2020377.06

**ADDENDUM No. 1**  
**FEBRUARY 15, 2023**  
to  
BID DOCUMENTS dated 01/06/2023  
for  
CITY OF CANTON – 2022 SERVICE CENTER UPGRADE AND  
RECONFIGURATION PROJECT – GP 1331  
2436 30<sup>TH</sup> STREET NE  
CANTON, OH 44705

**C-101**

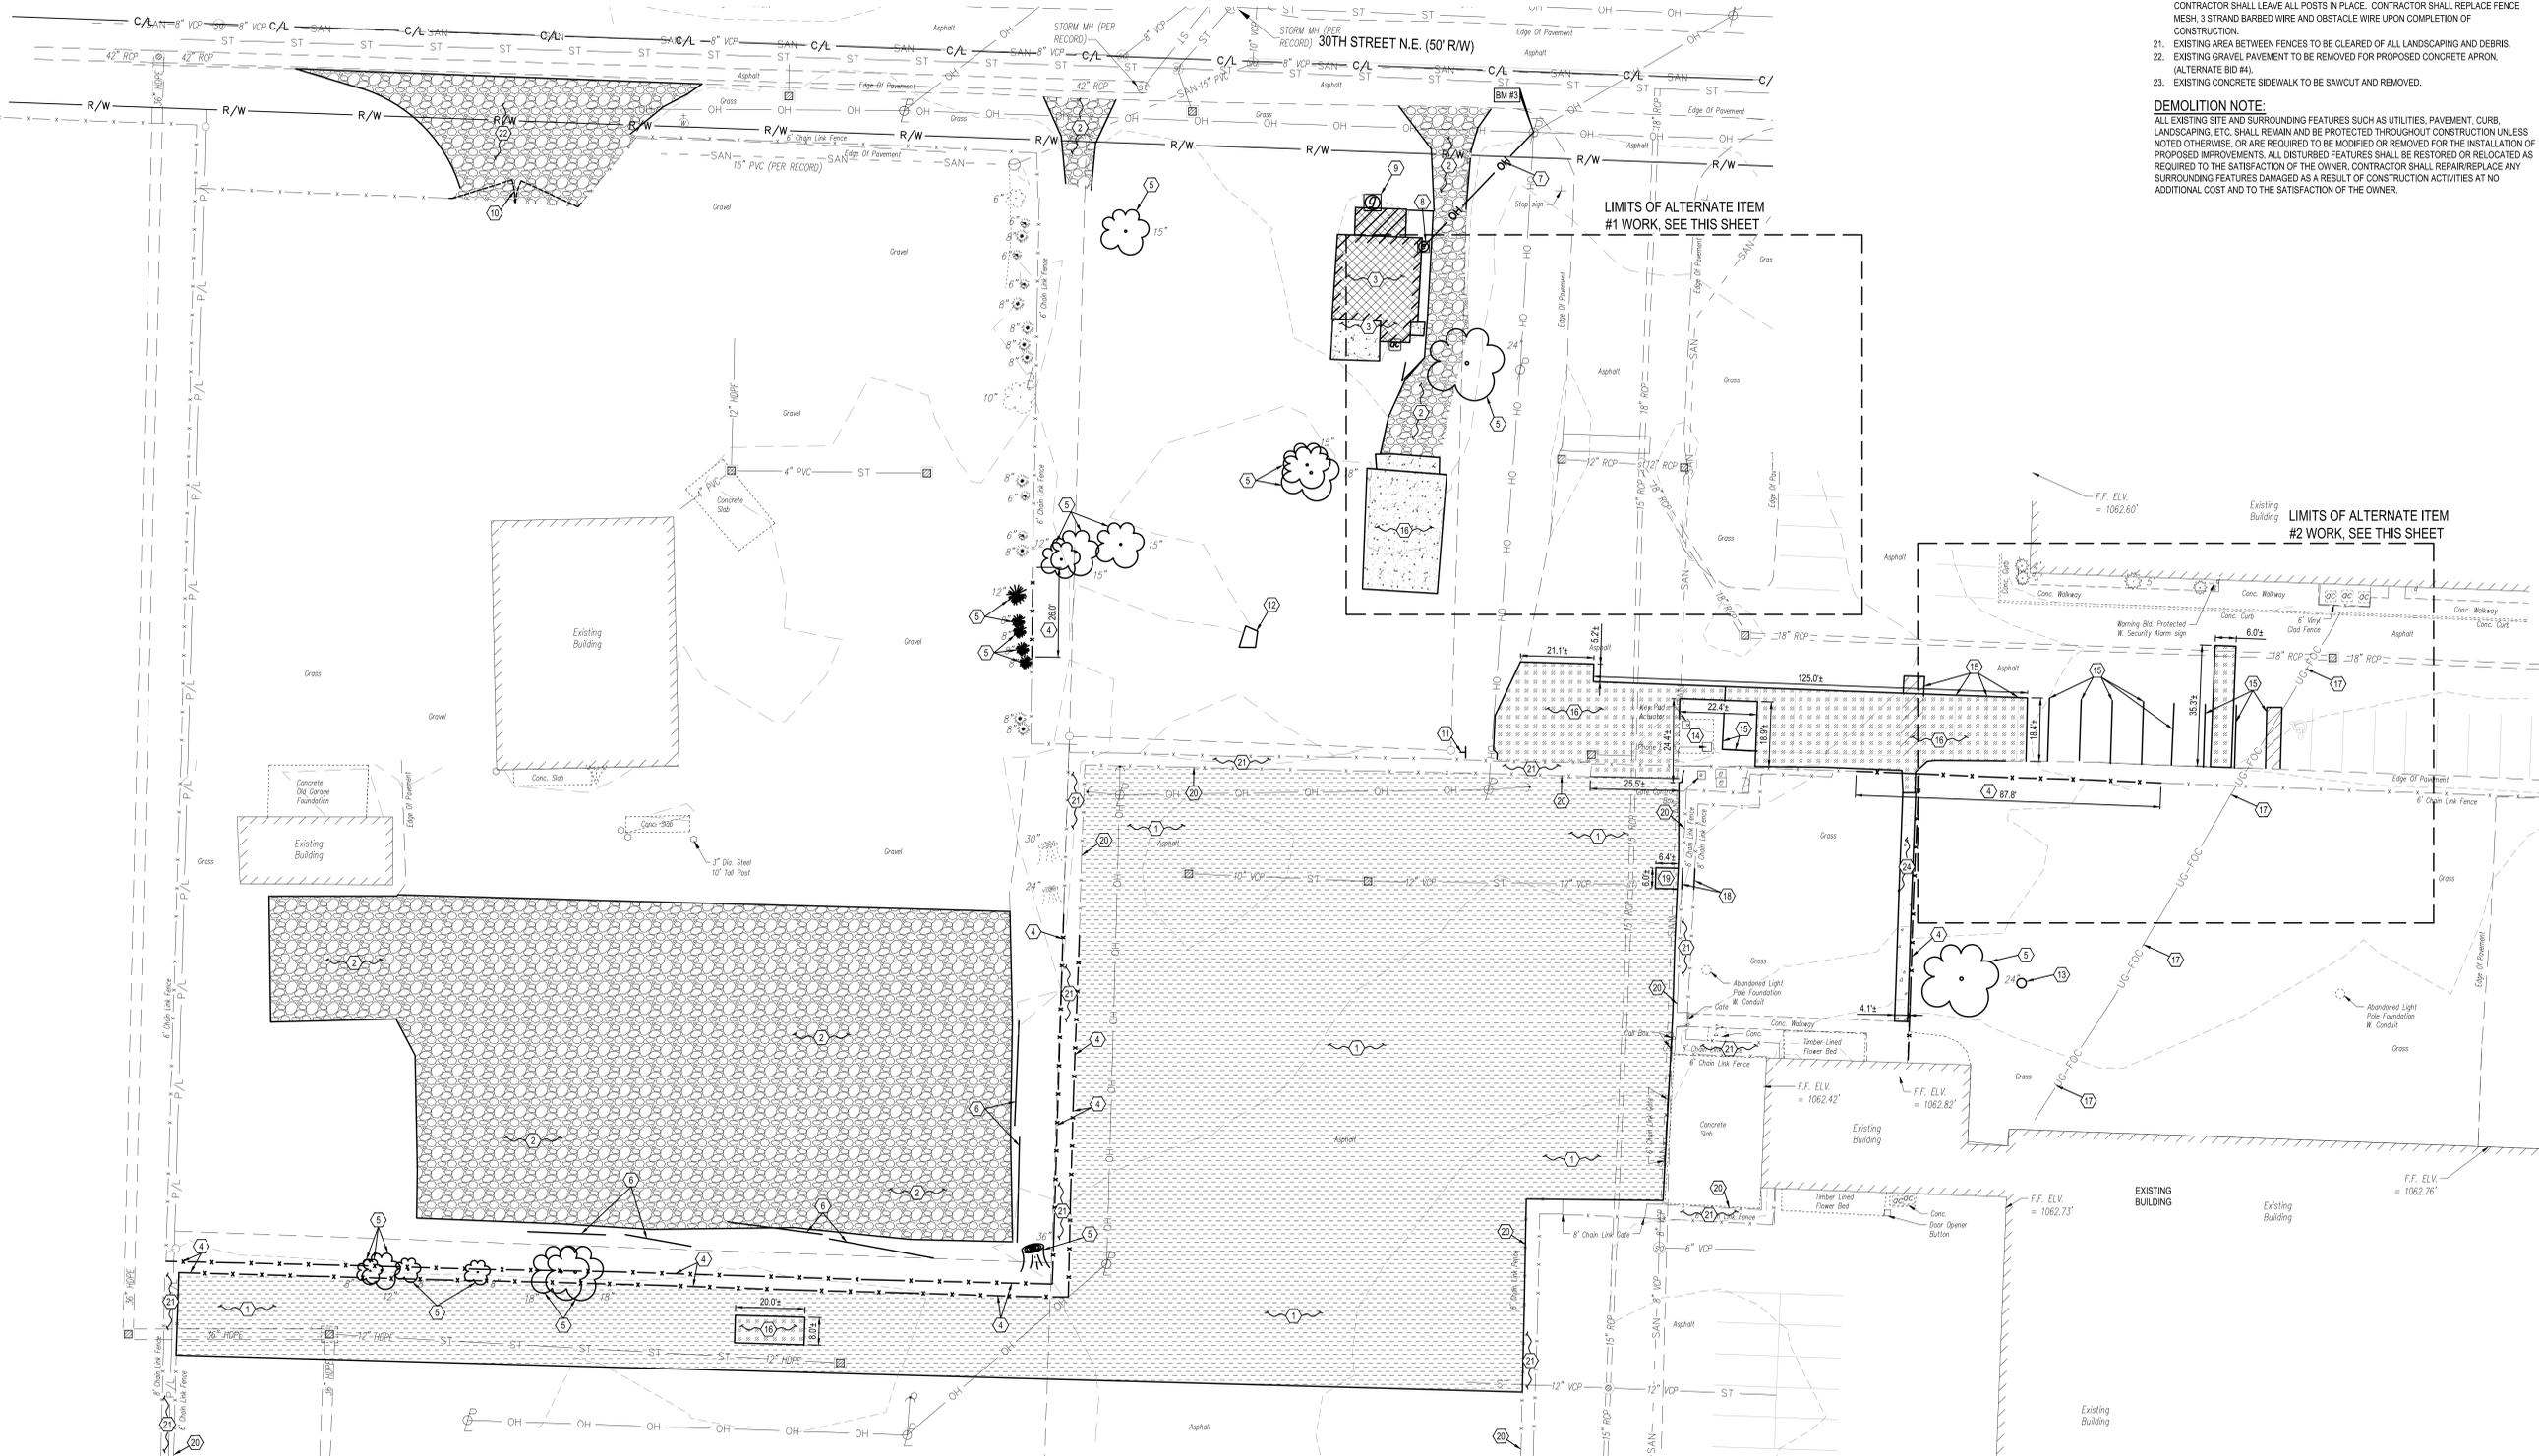
1. C-001 GENERAL NOTES
  - a. Revised Sanitary Sewer Note #1.1
2. C-101 DEMOLITION PLAN NORTH
  - a. Revised Plan Keynote #3.
3. C-101 DEMOLITION PLAN SOUTH
  - a. Revised Plan Keynote #4.

1. EXISTING CHAIN LINK FENCE TO BE REMOVED.
2. EXISTING GRAVEL PAVEMENT TO BE REMOVED BY OWNER PRIOR TO CONSTRUCTION.
3. EXISTING PILE OF CONSTRUCTION DEBRIS TO BE REMOVED BY OWNER PRIOR TO CONSTRUCTION.
4. EXISTING PAVEMENT TO BE SAWCUT AND REMOVED.
5. EXISTING 6" INTERIOR FENCE MESH, 3 STRAND BARBED WIRE, AND OBSTACLE WIRE BETWEEN FENCES TO BE CAREFULLY REMOVED AND STORED DURING CONSTRUCTION. CONTRACTOR SHALL LEAVE ALL POSTS IN PLACE. CONTRACTOR SHALL REPLACE FENCE MESH, 3 STRAND BARBED WIRE AND OBSTACLE WIRE UPON COMPLETION OF CONSTRUCTION.
7. EXISTING AREA BETWEEN FENCES TO BE CLEARED OF ALL LANDSCAPING AND DEBRIS.
